SERVICE LETTER No. L 144-Rev.2

MODEL AFFECTED: Z 242 L aircraft, S/N: 0685

SUBJECT: Aircraft manufacturer instructions for detected cracks and defects and repair instructions.

Fig. No. 1

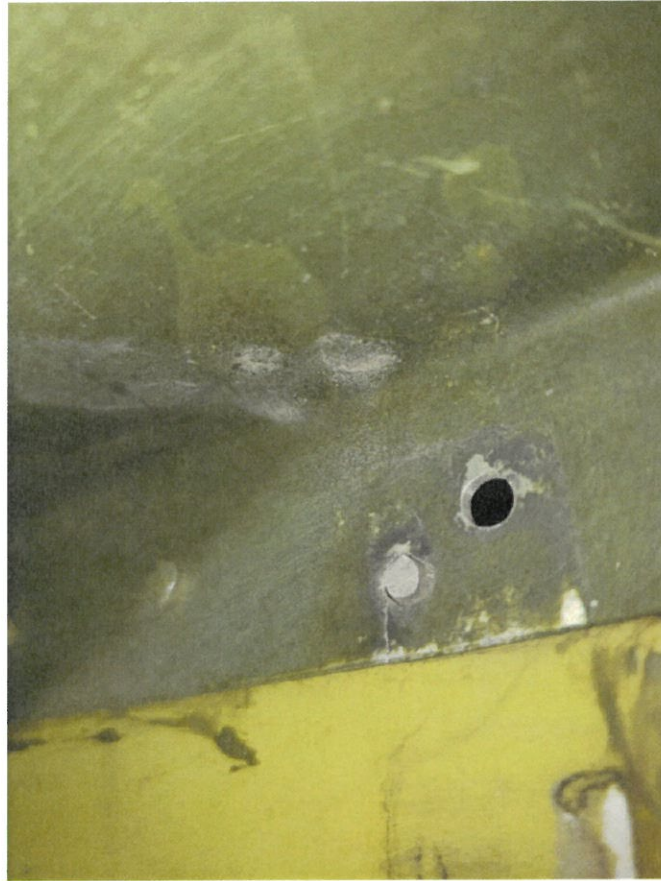
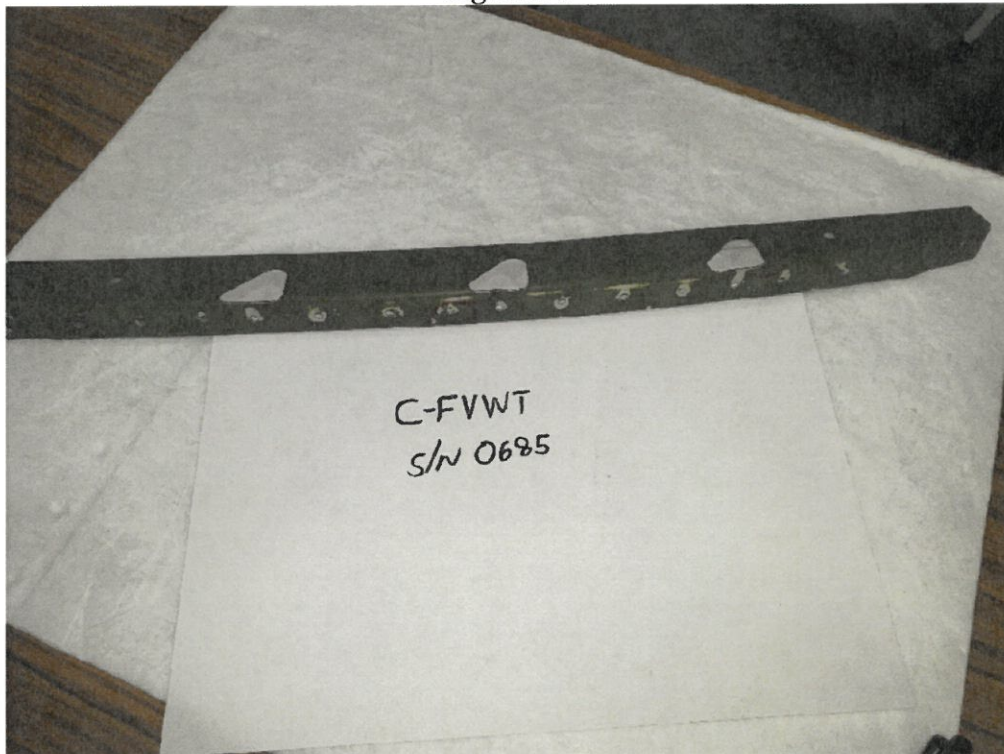
The operator reported the cracks disclosed during the regular servicing of the airplane's structure. The reported findings were considered by the Commission of Airworthiness and Reliability of ZLIN AIRCRAFT a.s. and its conclusion is that the cracks are repairable with no impact on airplane's airworthiness:

- 1) The rear part of the left root rib (see Fig. 1 and No. 2) The length of the crack is 3mm.

PROCEDURES: For corrective actions recommended by the manufacturer follow the repair procedures recommended by the FAA document AC-43.13-1B, issued on 8 SEP 98 as follows:

Repair the rib cracks as described on pages 4-17, 4-30 and 4-37 of the above-mentioned document. The final state of the repaired rib as follows:
